Subject: Biosolids Pelletization Facility  
Pug Mill Water Sprays and Recycle Bin Dust Collectors  
Title V Air Operating Permit No. 0990234-022-AV

The Solid Waste Authority of Palm Beach County ("Authority") owns a Biosolids Pelletization Facility ("BPF") that is collocated with the Authority's North County Resource Recovery Facility in West Palm Beach, Florida. The BPF has two (2) sludge dryer trains (EU010 - Train # 1 and EU011 - Train #2). It is operated by NEFCO under Title V Air Permit No. 0990234-022-AV.

**MATERIAL FLOW DIAGRAM RECORD DRAWING**

FIGURE 1: DRYER SOLIDS SYSTEM MAJOR COMPONENTS  
(Source: NEFCO O&M Manual, Revision 3, dated October 2009)

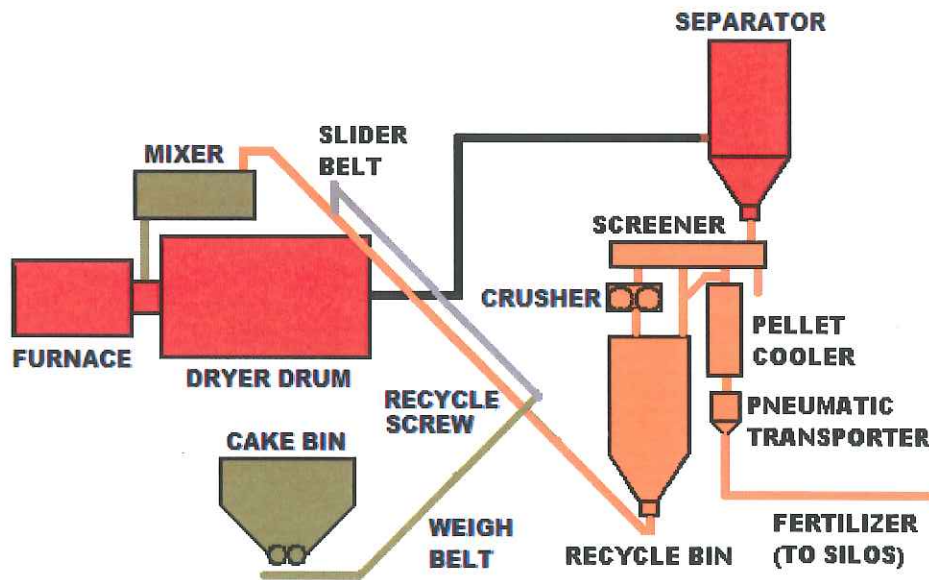
Mixer feed conveyors (“recycle screws”) are used to move dry material from the recycle bin to the pug mill (“mixer”), as seen in Figure 1 below. As the dry material is being transported on the conveyor to the pug mill, wet sludge cake drops from the weigh belt, through the sludge chutes (not pictured in the figure), onto the mixer feed conveyors/recycle screw. When the wet sludge cake drops onto the dry material from the recycle bin, a puff of fugitive dust goes back up the sludge chutes and into the room at the top of the chutes. The movement of dust up the open-top sludge chutes is facilitated by the warm air that rises off of the hot, dry material from the recycle bin.

**ATTACHMENT 1**

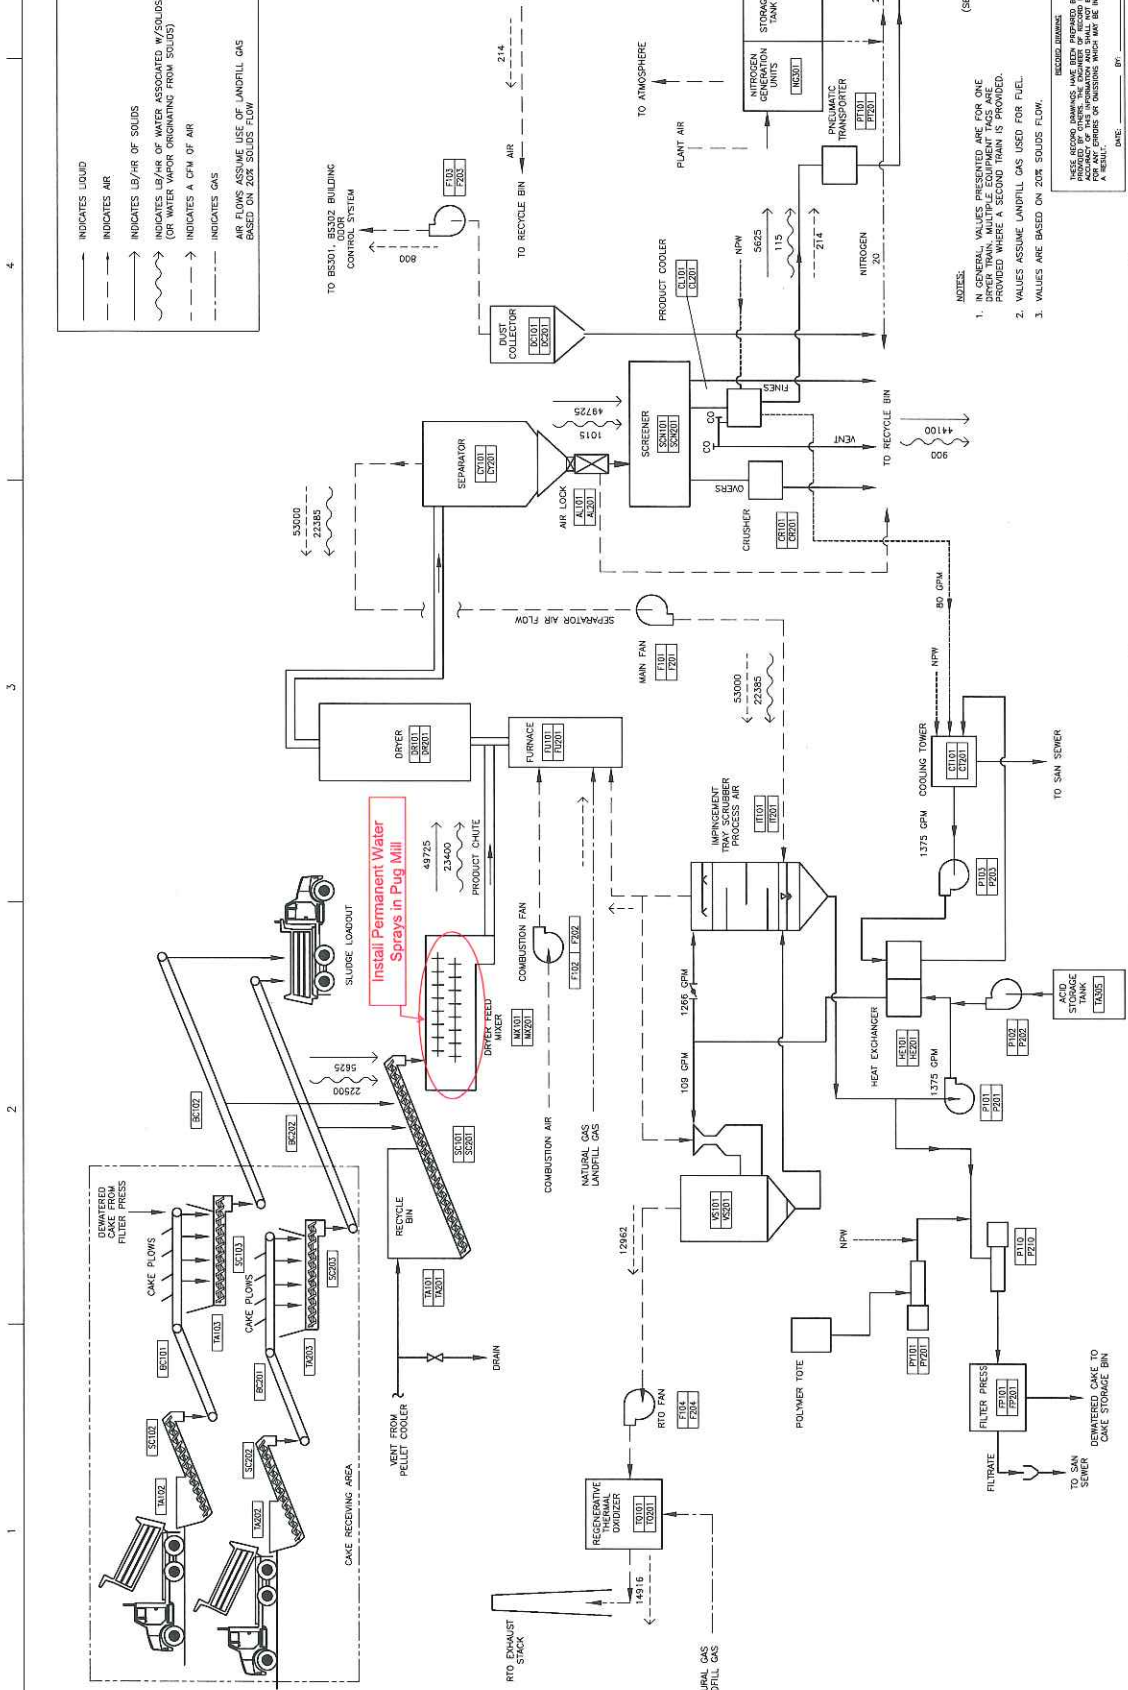
Attachment 1 to this letter is a Material Flow Diagram for the BPF. In this diagram, the pug mill is identified as the Dryer Feed Mixer and it is circled in red. The diagram shows how the wet sludge cake (i.e., Dewatered Cake from Filter Press) and the dry material from the Recycle Bin enter the pug mill (i.e., Dryer Feed Mixer) and then move through the Product Chute to the Dryer. A note on this diagram indicates that the permanent water sprays will be installed in the pug mill.

**MATERIAL FLOW DIAGRAM RECORD DRAWING ATTACHMENT 2**

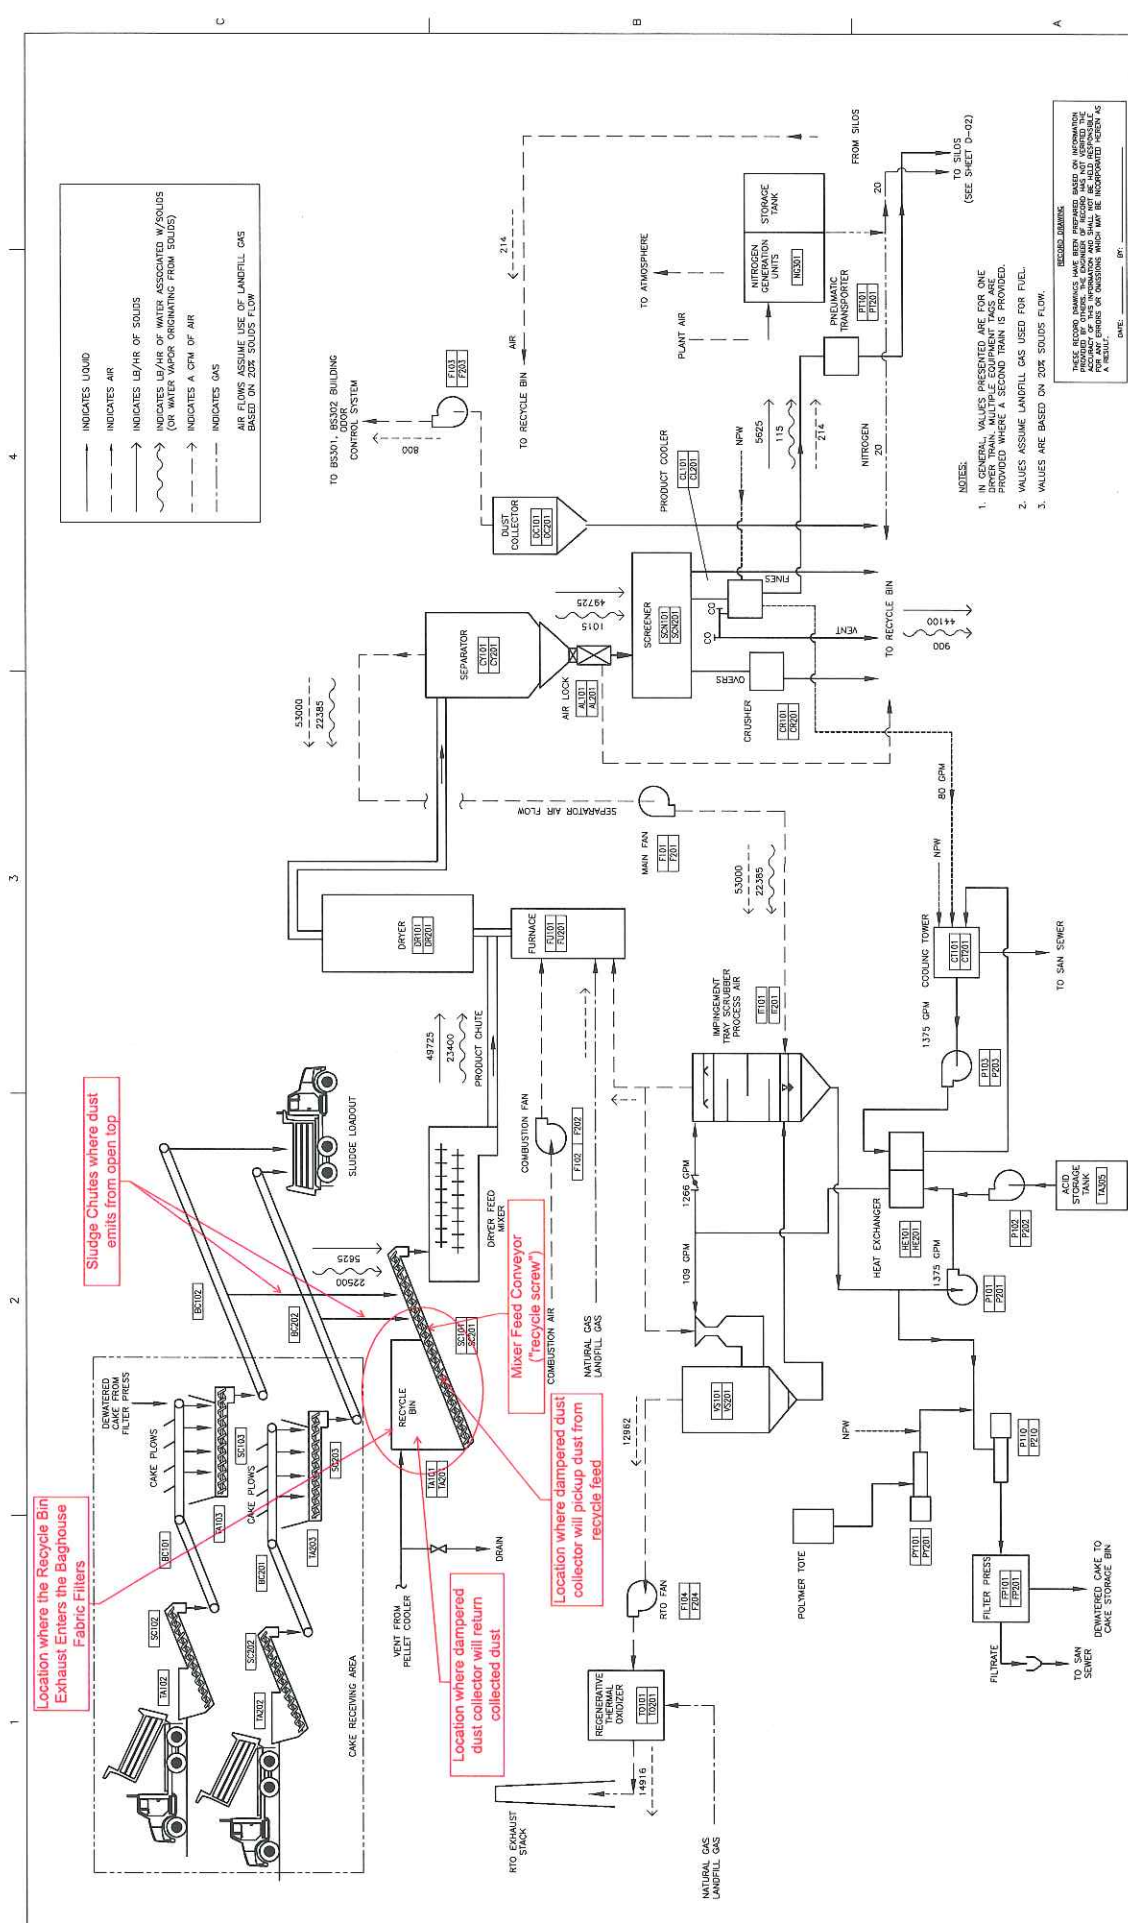
The Authority intends to install a single dust pickup line that will collect dusty air from the mixer feed conveyor prior to the sludge chutes, and will convey the dusty air to the top of the recycle bin. This dust pickup line will be installed with dampers so that the plant operator may adequately balance the flow of dust and limit the uptake of dry pellets back into the recycle bins through the new dust pickup line. One dust pick up line will be installed in each process train. Attachment 2 to this letter is a Material Flow Diagram that identifies the general location where the proposed system will pick up dust from the mixer feed conveyor. This diagram also notes that the collected air will be returned to the recycle bin.

Sludge Chutes where dust emits from open top

Location where dampened dust collector will return collected dust

Location where dampened dust collector will pickup dust from recycle feed
